Sent: 20/02/2020 9:20:51 AM
Subject: 1 Tabalum Road, Balgowlah Heights 2093 DA 2020/0077 WRITTEN
SUBMISSION: LETTER OF OBJECTION
Attachments: Submission Gazzilli DA 2020 0077.docx;

1 Tabalum Road, Balgowlah Heights 2093

DA 2020/0077

WRITTEN SUBMISSION: LETTER OF OBJECTION

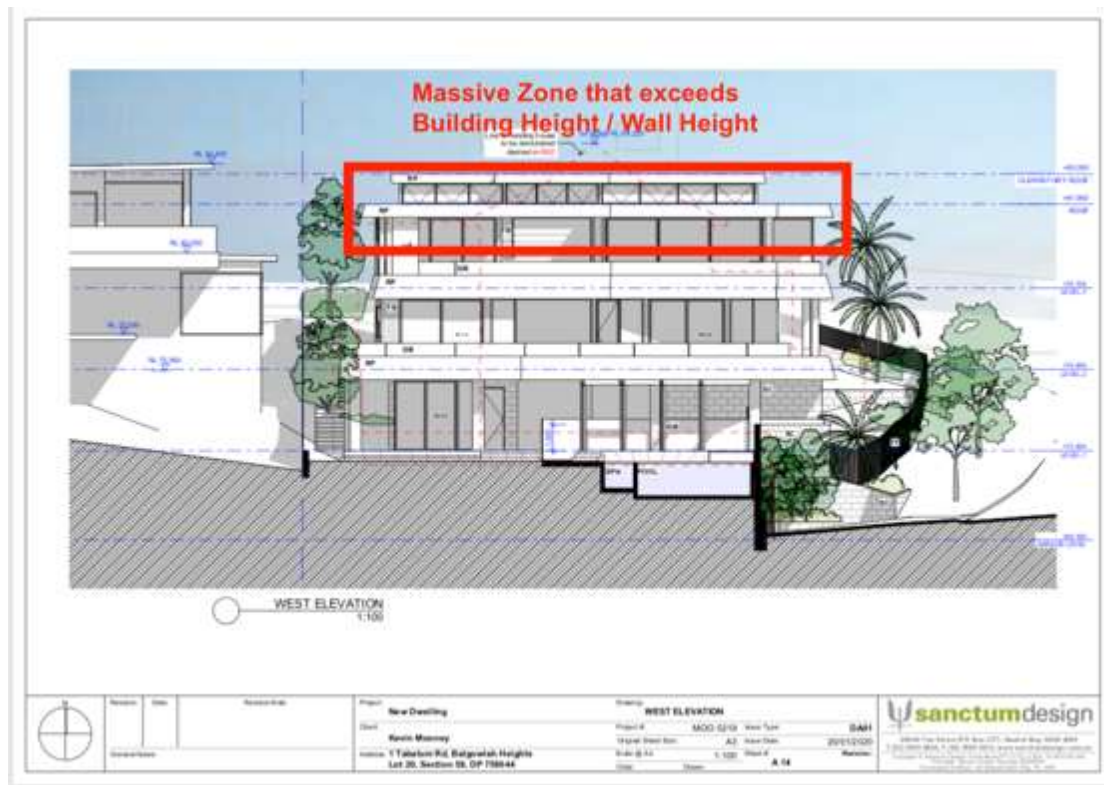
There is a very major portion of the western elevation over height controls, as seen in the attached sketch:

The Height, Form and Footprint all exceed LEP and DCP controls. Clause 4.6 FSR assessment has not been submitted against a non-compliant FSR. Amenity loss occurs, and that is considered a totally unreasonable outcome.

1 Tabalum: Non-compliant proposed development

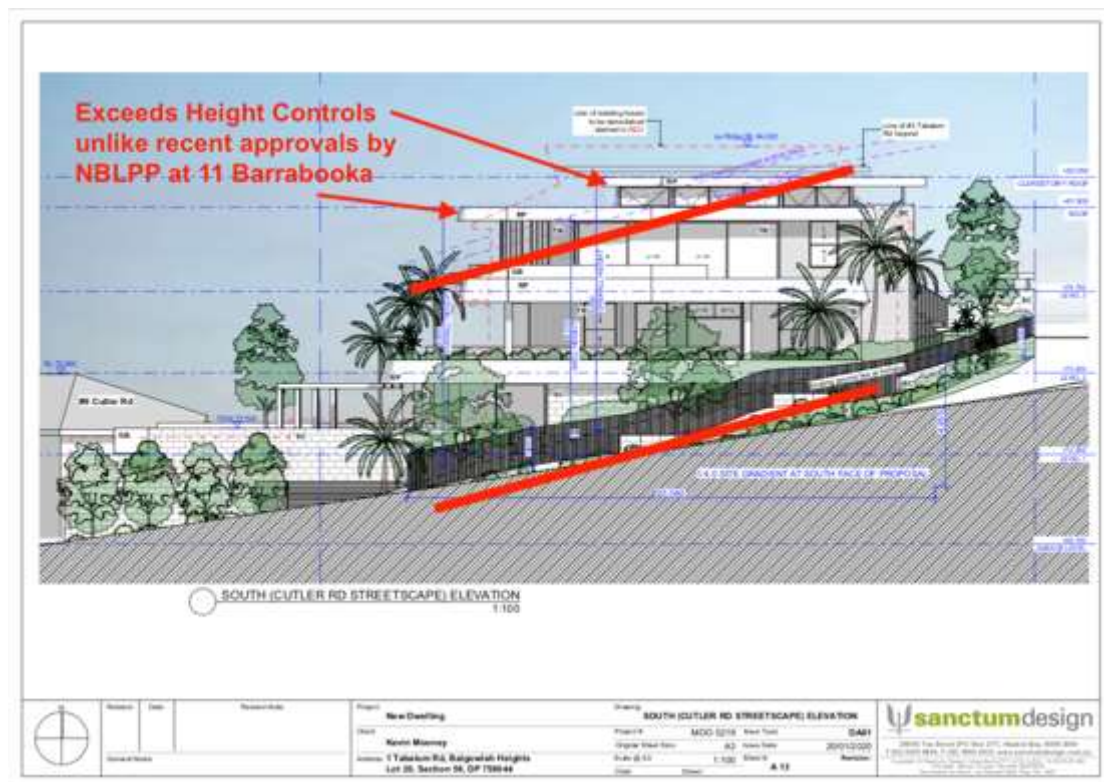
The only recent new build DA approved by the NBLPP & LEC in the area was on #11 Barrabooka, [DA 371/2016, approved 2017 & 2018] and that approval required the Applicant to reduce building heights under the 8.5m level, and to accord with setback controls. The existing building was significantly higher than the controls, however NBLPP & LEC restricted building heights below 8.5m.

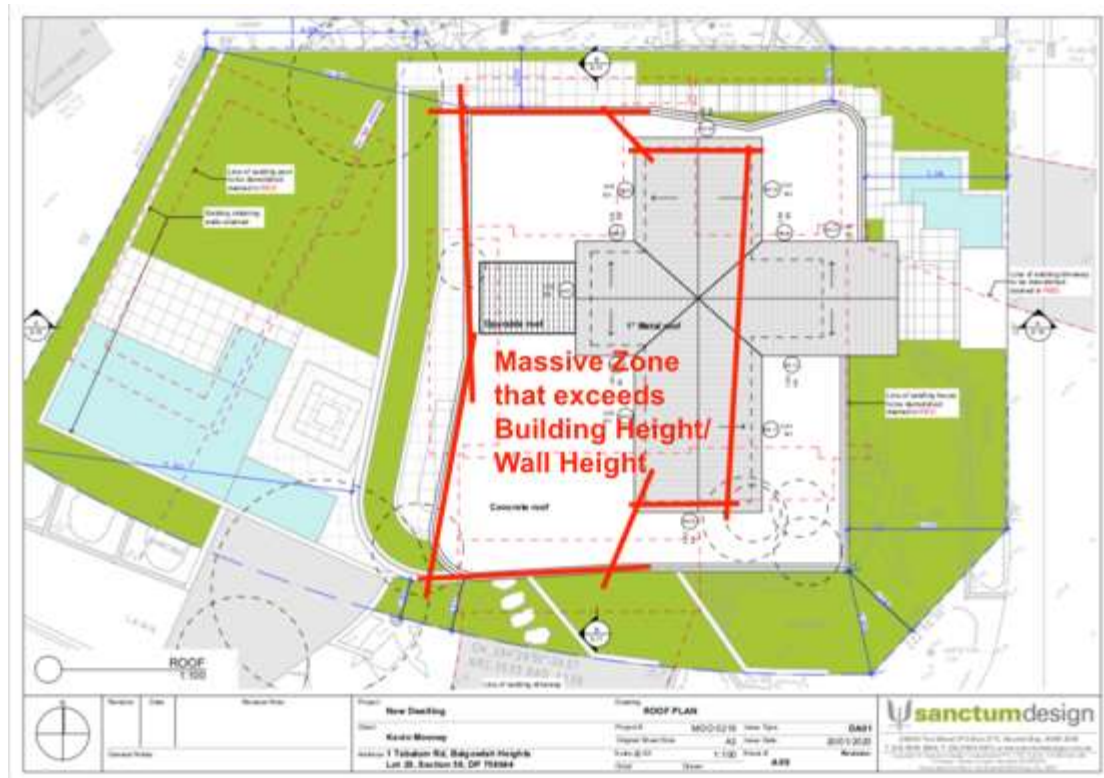
Control 8.5 m

Proposed 10.74 m [clerestory at SW corner, survey RL 72.31] and 10.22m [roof at SW corner, survey RL 71.68]

The proposed development does not provide for building heights and roof forms that are consistent with the topographic landscape, prevailing building height and desired future streetscape character in the locality. The proposed development does not control the bulk and scale of buildings.

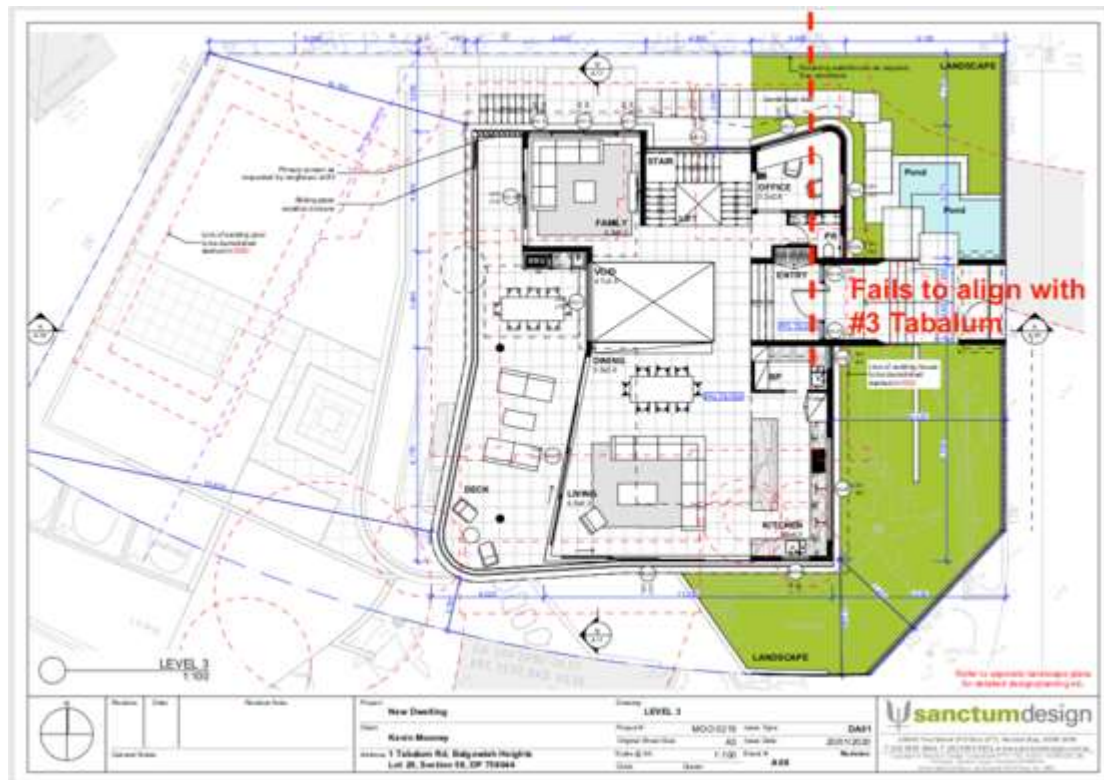
Control #3 Tabalum at 7.0m

Proposed 6.13 m

The non-compliant front setback adds to the loss of view to the iconic Sydney Harbour Heads. I ask for a compliant front setback that relates to 3 Tabalum.

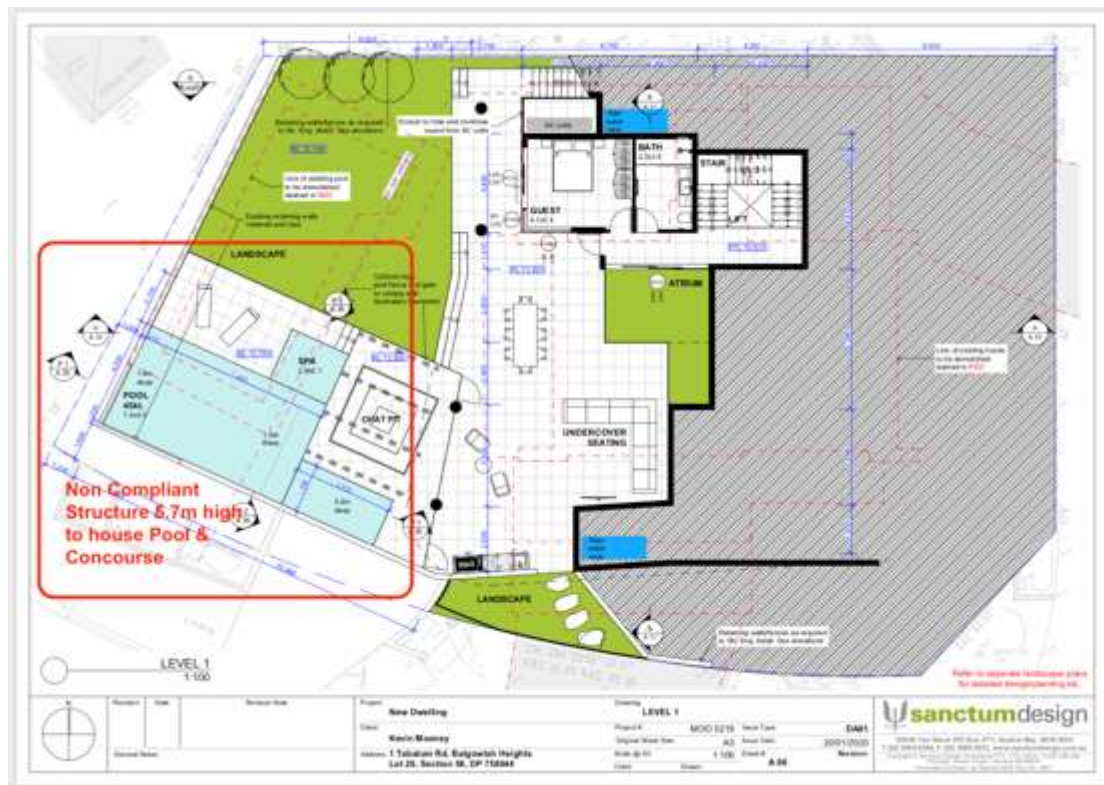
I am concerned that a major new build element of the proposed development, namely the elevated pool is built into the rear setback zone.

The new structure is part of the building considering that the built form rises to RL 73.9 over the adjacent levels at the south-west corner at RL 68.18. This represents wall heights of up to 5.72m, which is effectively a two storey structure, built into the rear setback zone.

This structure is built only 1.23m from the western boundary, and 1.685m from the southern street boundary.

No consideration to privacy, additional overshadowing, and visual bulk has been considered in this respect.
